## **Fairmont Park- Bathroom Building**

*Transition Plan - (location/priority)*

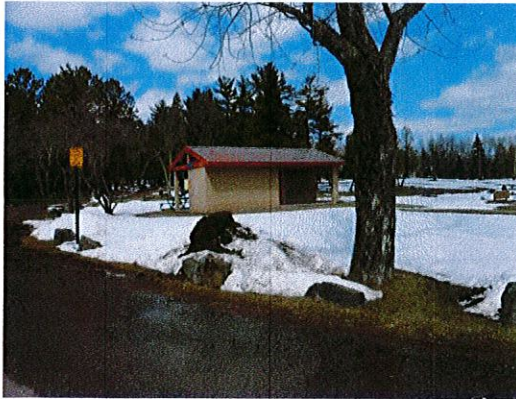
**Photo 1:** Create an accessible route to the toilet room building.

**Photo 2:** Eliminate the 4" rise at the concrete stoop to the men's toilet room.

**Photo 3:** Enlarge the concrete landing to provide maneuvering clearance on the exterior side of the men's toilet room door.

**Photo 4:** Eliminate the 4" rise at the concrete stoop to the women's toilet room and enlarge the concrete to provide maneuvering clearance on the exterior side of the door.

**Photo 5:** An ambulatory accessible stall has been provided, but not a 5' wide stall.
